Staff Report

REPORT NO.: DSD-2025-046

SUBJECT: Minor Variance Application A2025-011 - 86 Florence Avenue
Minor Variance Application A2025-012 - 86 Florence Avenue
Consent Application B2025-004 - 86 Florence Avenue
Consent Application B2025-005 - 86 Florence Avenue

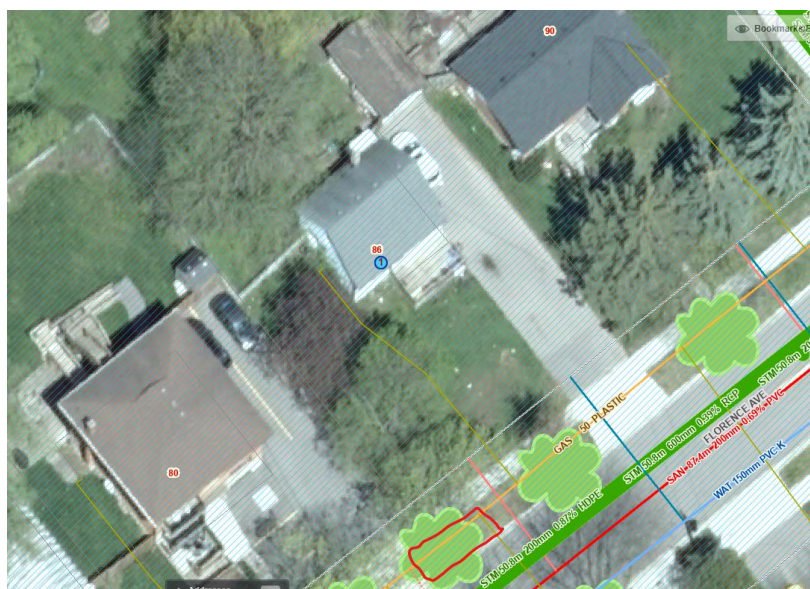
There are existing City-owned street trees that will be impacted by the proposed development. Forestry staff have considered the proposed design and compensation for the tree located in the middle of the existing lot will be accepted in the form of cash-in-lieu. The cash-in-lieu required for the removal of tree #10037950 is **\$3600.00** and required prior to deed endorsement of B2025-004, B2025-005 or building permit issuance which ever occurs first. The City owned street tree located at the southwest corner of the property **should be protected in place to City standards throughout all demolitions and construction**. Please see image below and <https://www.kitchener.ca/en/water-and-environment/tree-bylaws-and-management.aspx>.

A2025-011:

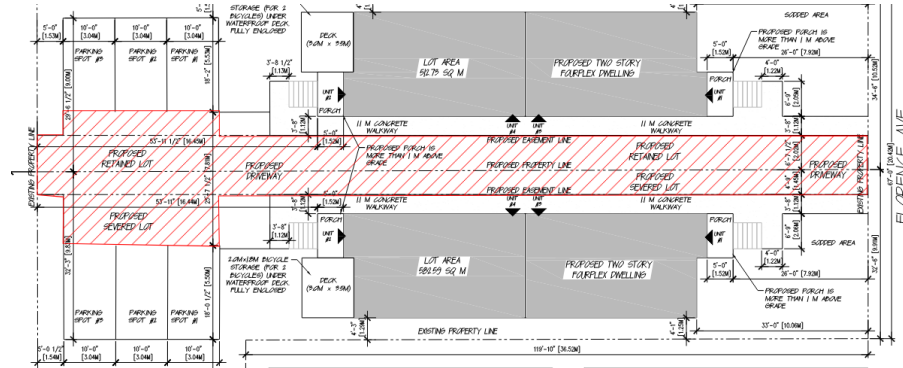
Transportation Services can support the requested driveway width of 1.45m, provided that a mutual access agreement be registered on title. See the red hatched area below.

A2025-012:

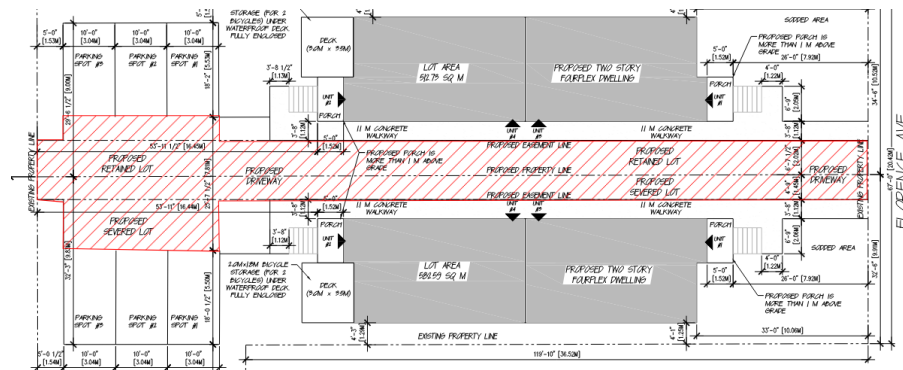
Transportation Services can support the requested driveway width of 2.02m, provided that a mutual access agreement be registered on title. See the red hatched area below.
